**Re: IFB #2021-08 LAVTA Rutan Landscaping Construction Project – Addendum
Number 3**

Addendum Number 3 to the above referenced IFB provides revisions to Special Provision #25, Payment and Invoicing Instructions, and responds to the Questions Posed by potential bidders with LAVTA narrative responses.

LIVERMORE
AMADOR VALLEY
TRANSIT AUTHORITY

OVERALL PLANTING PLAN

L1

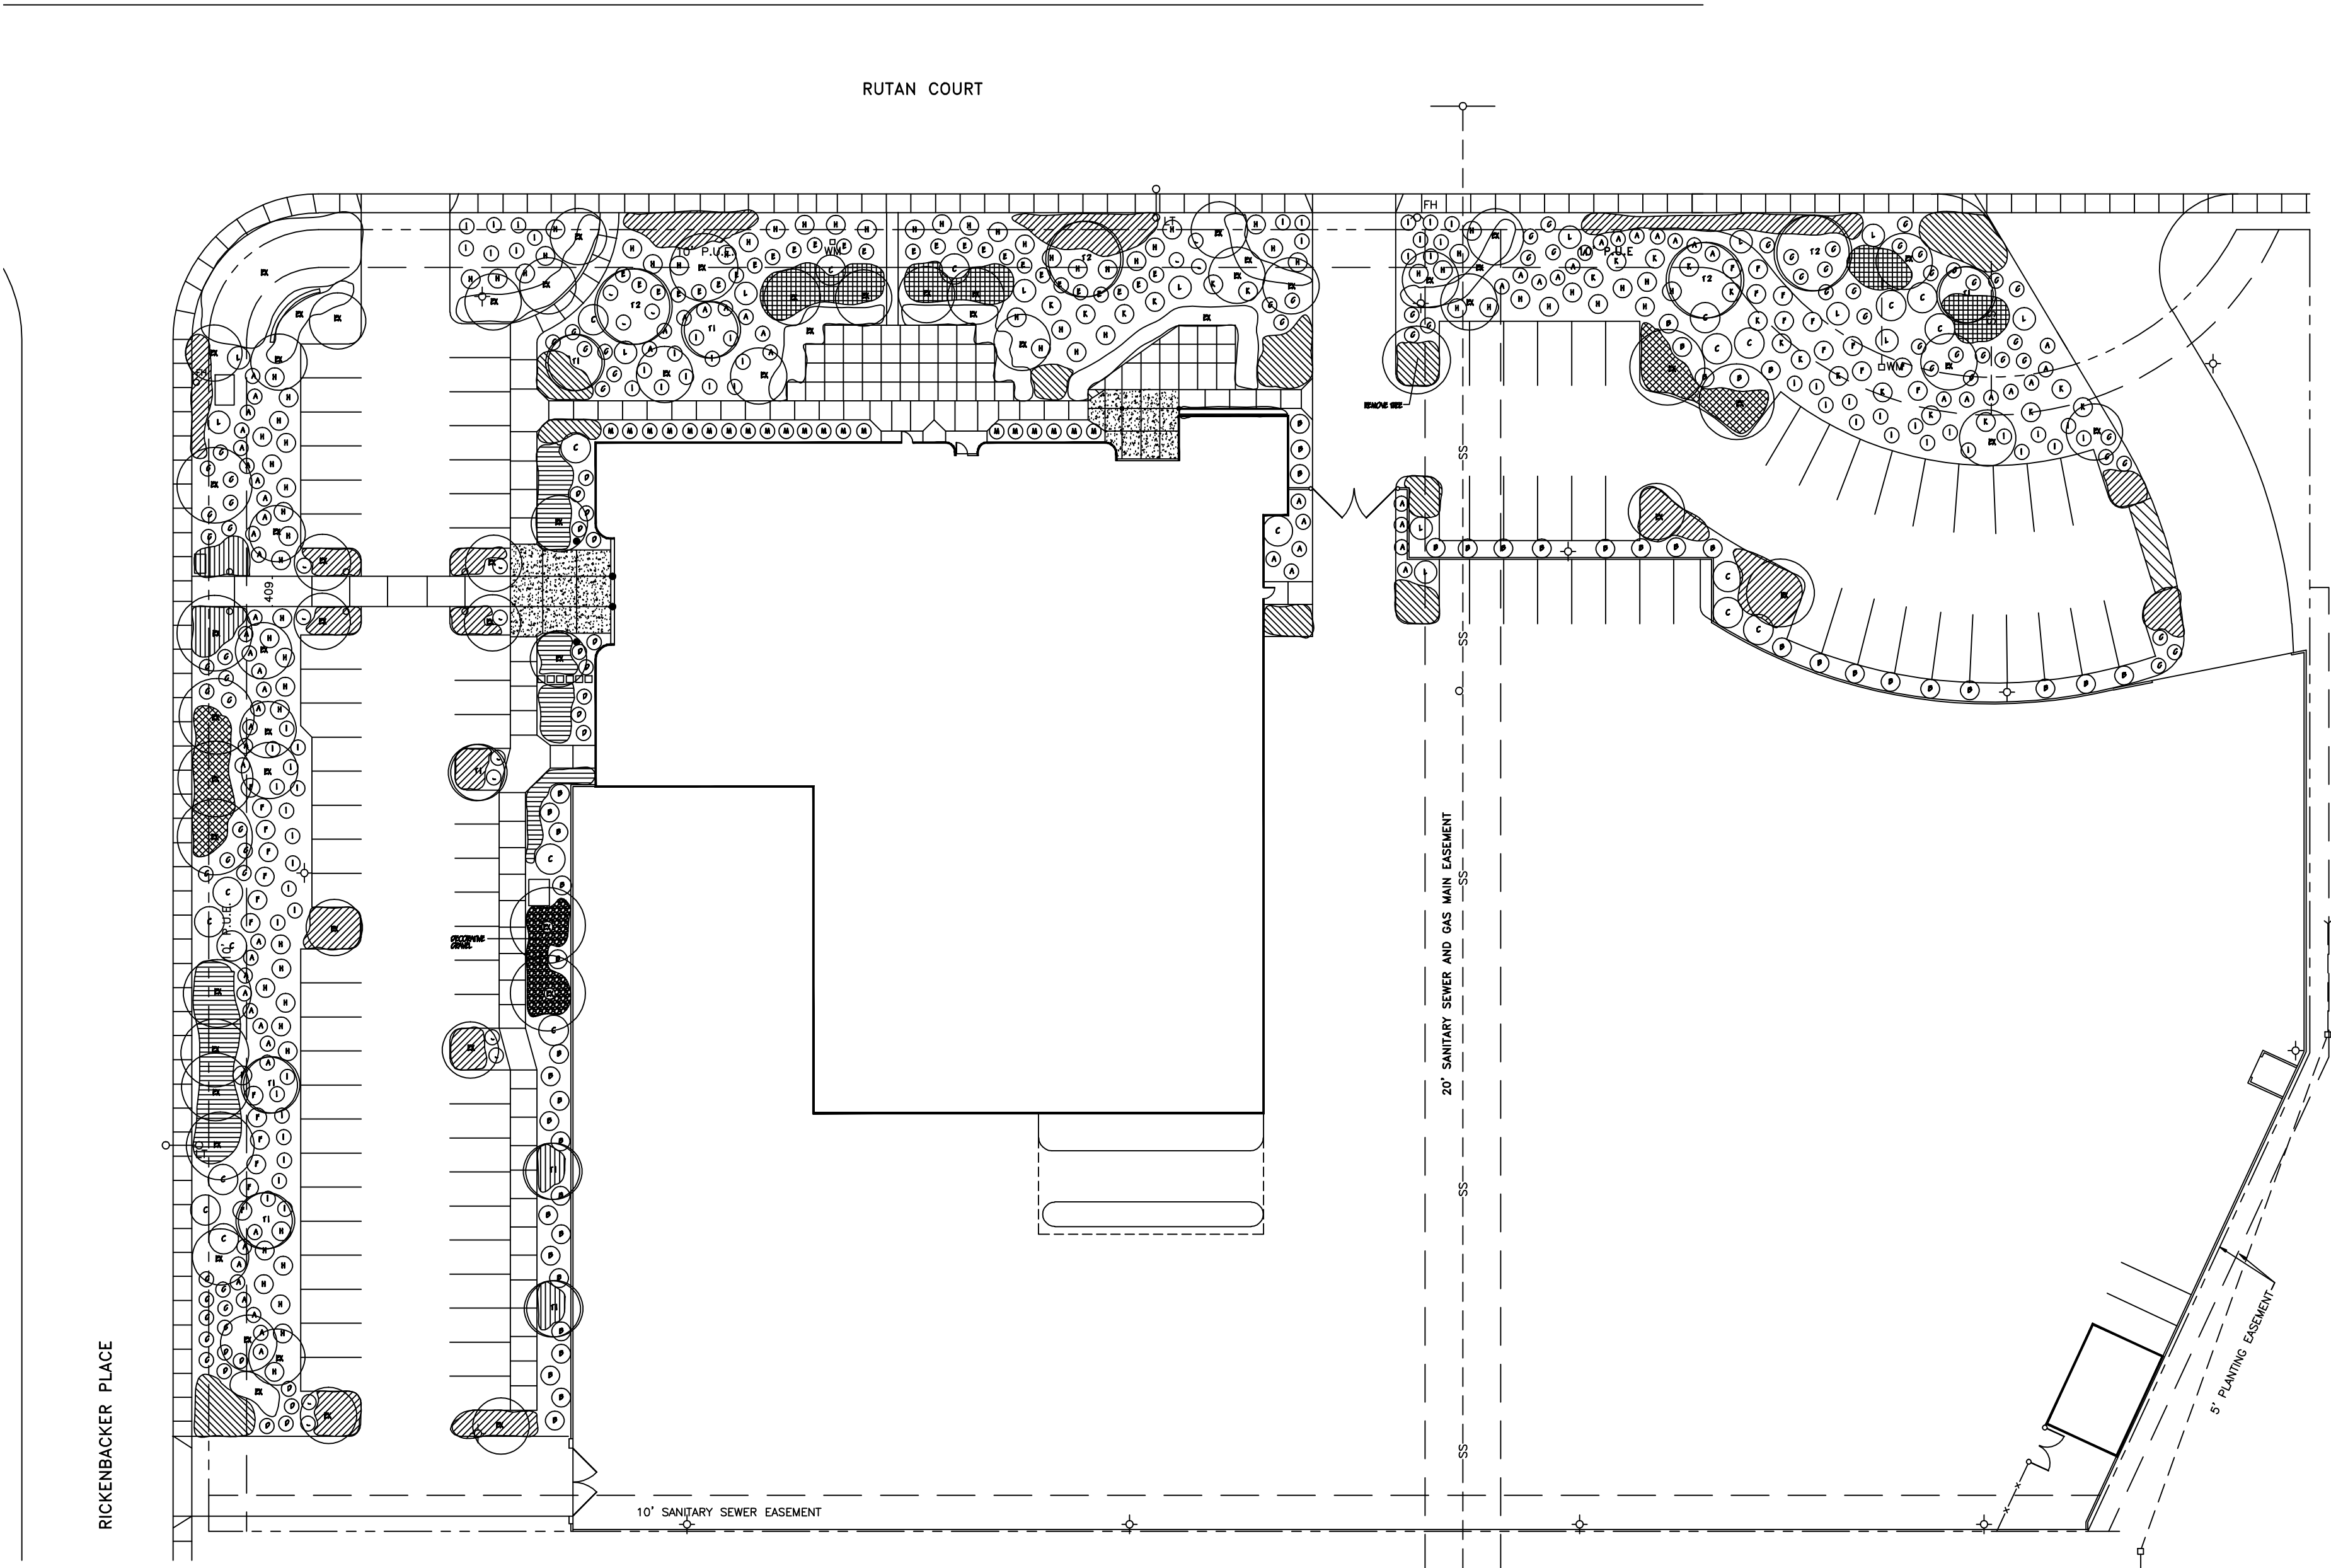
14	Please provide installation details for irrigation controller and gate valve.	Please see update Sheet L 11 attachment #4.
15	Please provide locations and depths where import soil is required. Will these areas be left low?	No soil import is specified at this time.
16	Please provide locations for quick coupler valves.	Need TBD in field.
17	Refer to sheet L5, please provide material type and installation detail for decorative gravel.	See updated sheet L 1 for specification attachment #2

18	Please provide manufacturer and model numbers for Irrigation security blankets.	See updated sheet L 1 for specification attachment #2
19	Please provide bid items for mulch, landscape maintenance and drip remote control valves.	See updated bid form
20	According to section 7, the work/TS-2, Landscape demolition does not address irrigation removals. Will existing sprinkler heads and lateral line be removed or capped and abandoned in place?	See question #6
21	Bidder has to be a signatory of the union to be able to bid this project if not could you confirm that bidder doesn't have to be signatory of union please	This project is a public works project and therefore prevailing wage must be paid. However, there are no requirements regarding unions.

OVERALL PLANTING PLAN

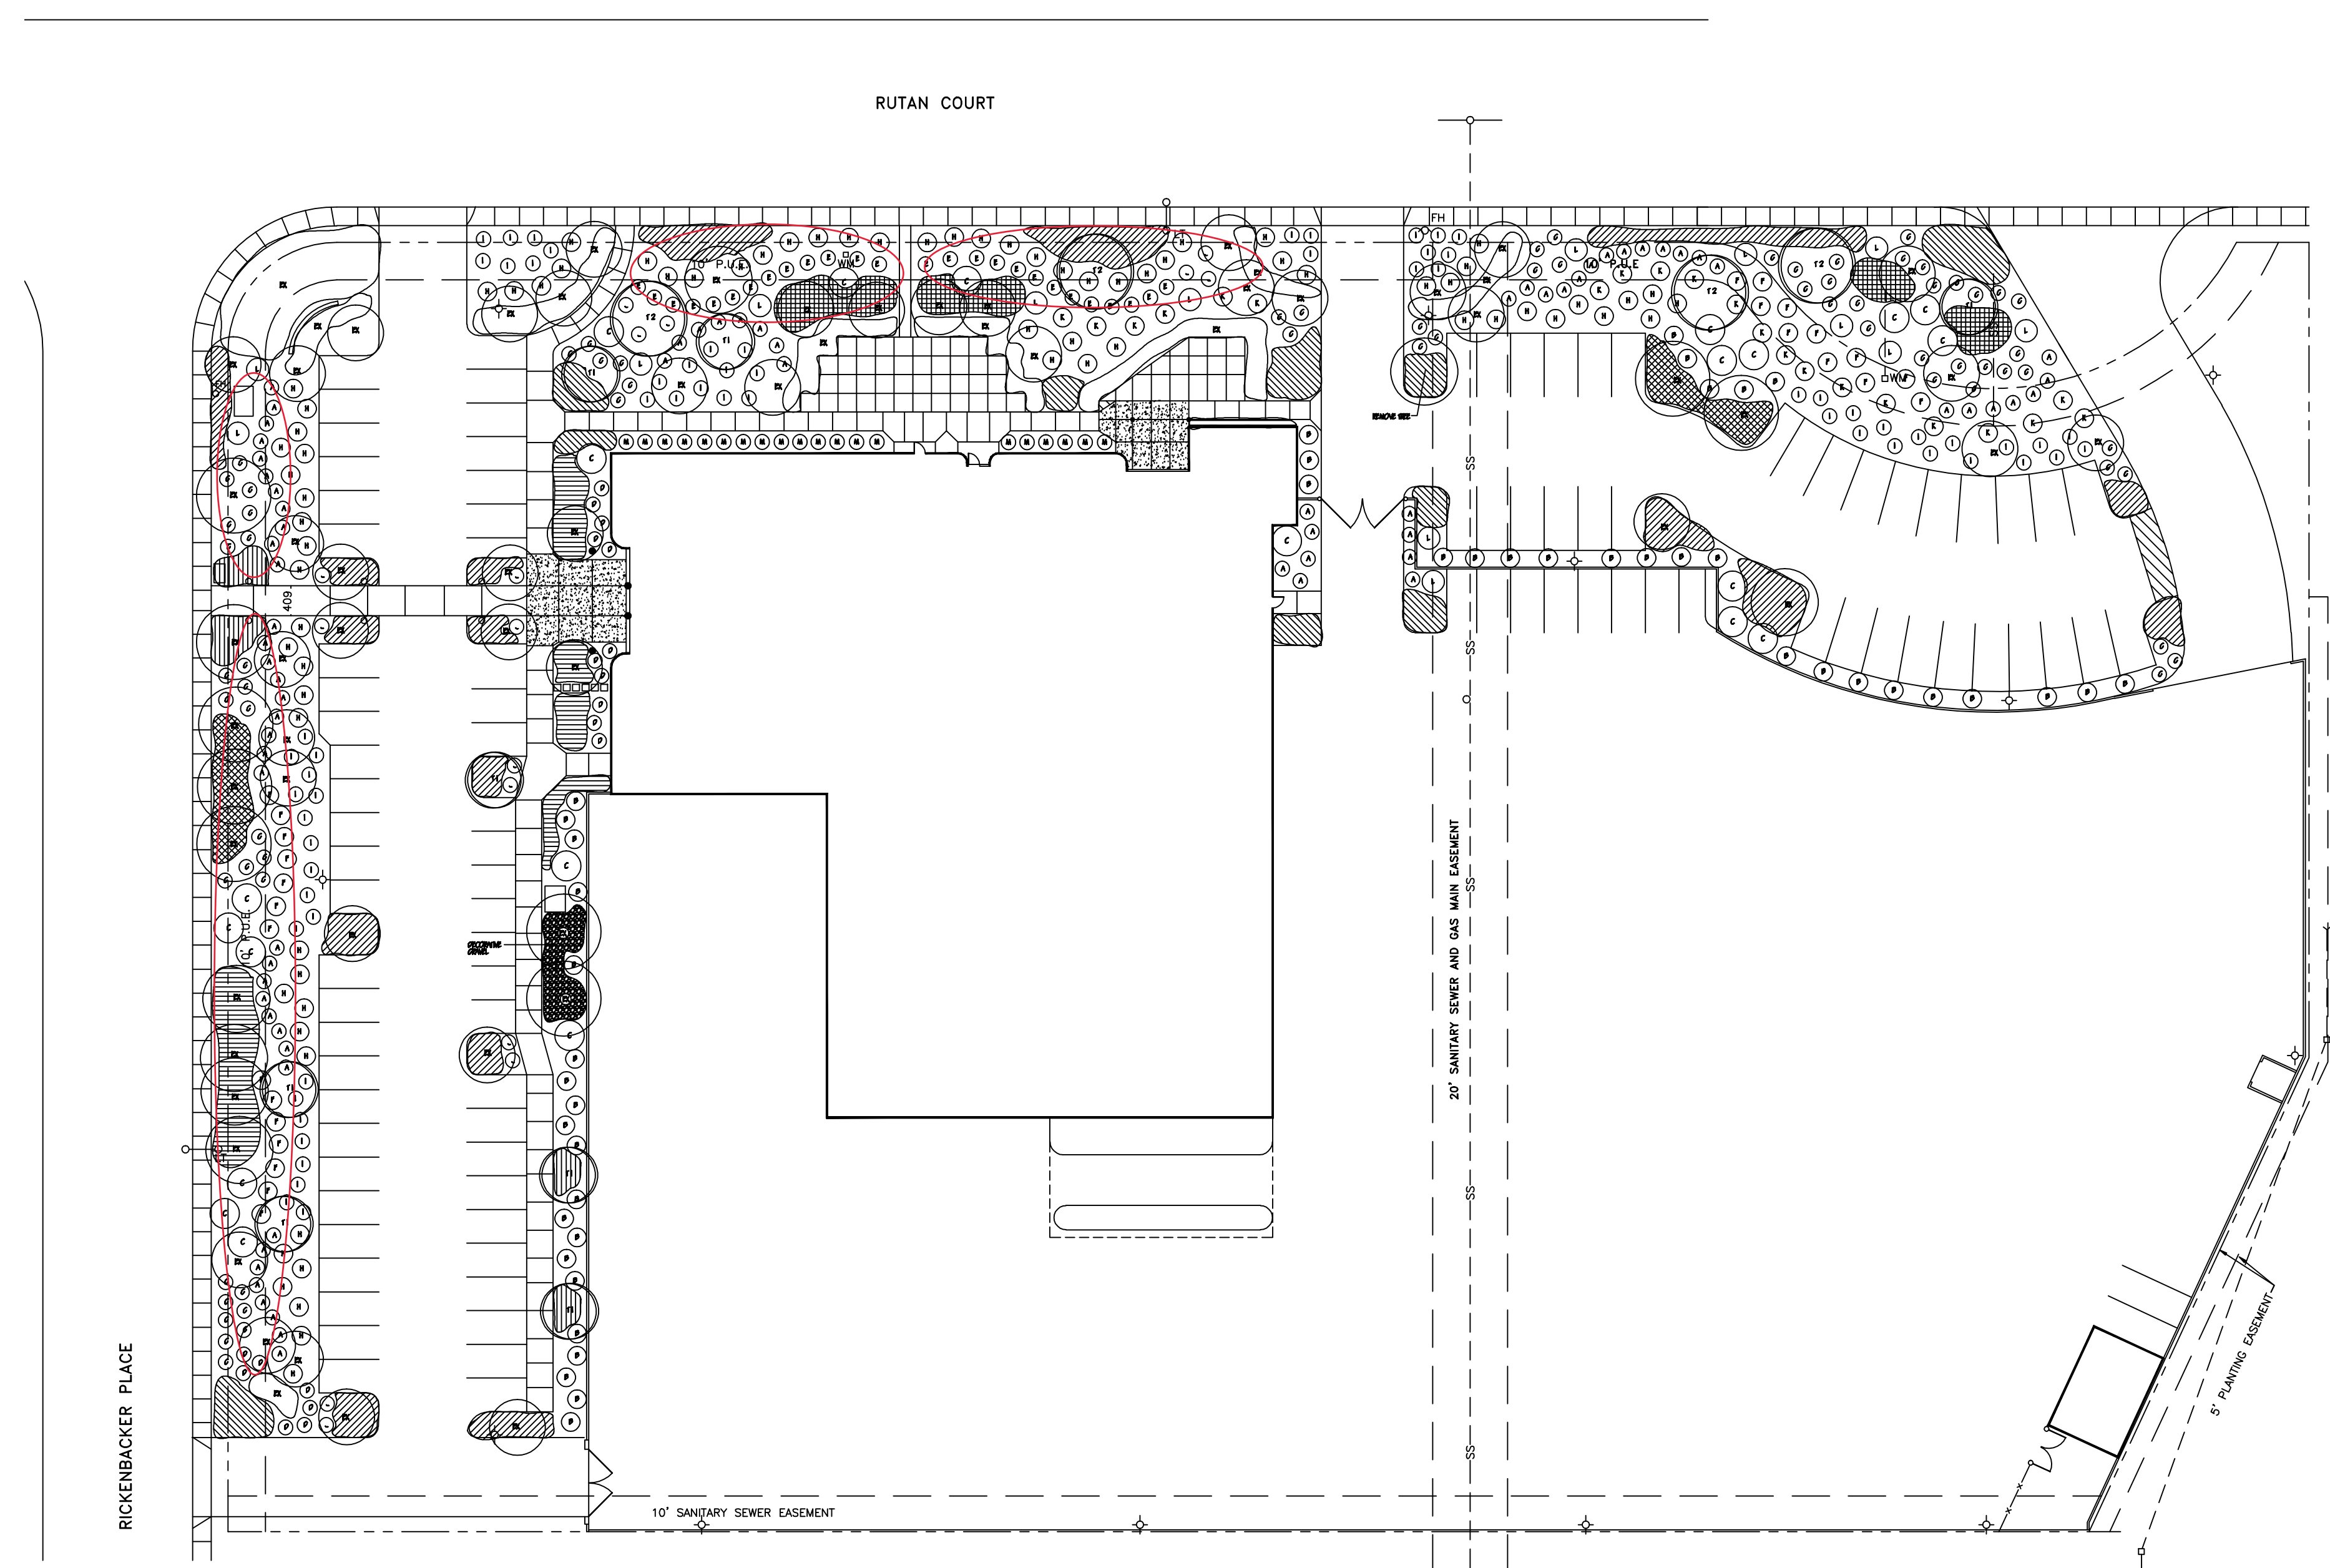
10	<p>Refer to note 3 in sheet L-6, please provide limit of work for existing mounded locations for soil preparation per the snip below.</p> <p>3) Thoroughly prepare soil prior to planting. See sheet L-6 for preparation specifications. For existing mounded locations, follow recommendations for sample 2. All other areas shall use recommendations from sample 1.</p> <p>4) Incorporate 4 cu of compost per 1000 sf, 6" into native soil.</p> <p>5) Spread 3" of recycled wood chip mulch (Prochip Mahogany or equal).</p>	See plan markup attachment 3.
11	Please provide landscape technical specifications.	Attachment #5 are general specifications
12	Please provide technical specification for tree protection.	See question #3
13	Refer to irrigation legend on sheet L11 stating backflow preventor, master valve, flow sensor may be required on this project. For bidding purposes, please confirm if these items will be required in the bid. If so, please provide installation details for backflow preventor, flow sensor, master valve.	Since we do not know if these will be required, if they are required they will need to be addressed in a change order.

APPROXIMATE AREA CONSIDERED "MOUNDED" FOR SOIL PREPARATION MEASURES
